SERVICE BULLETIN

APPLICABILITY: 2014 Forester Models

NUMBER: 07-80-13R

SUBJECT: Power Rear Gate (PRG) Inoperative,
Incomplete Initialization Procedure

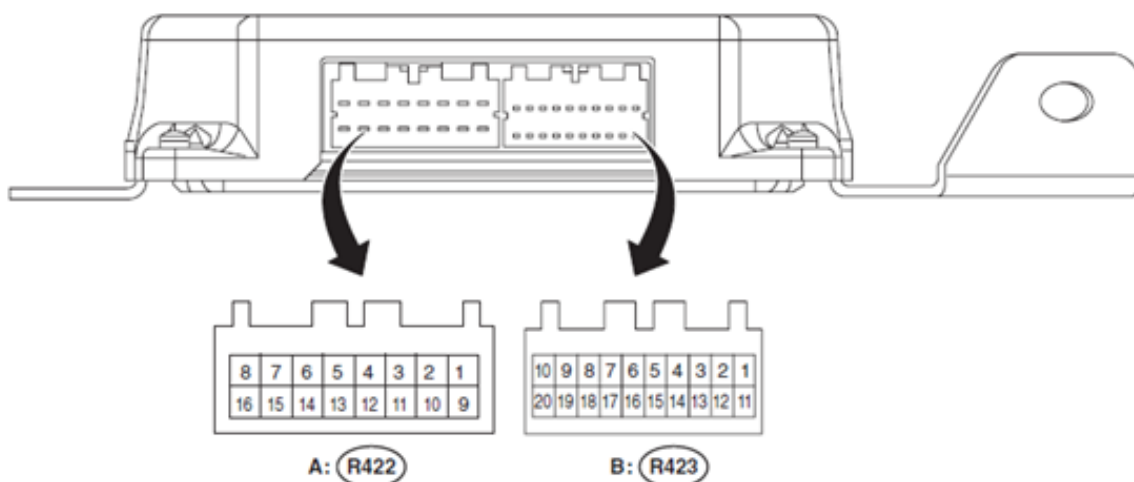
- **IMPORTANT:** In the event the PRG control module harness connectors are disconnected (e.g. diagnosis, control module replacement, etc.), **ALWAYS** reconnect (B:) R423 **BEFORE** reconnecting (A:) R422 as illustrated below. If this reconnection order is not followed, other PRG DTCs may set. In addition, the ignition switch must **ALWAYS** be **OFF** before disconnecting or reconnecting the PRG control module.
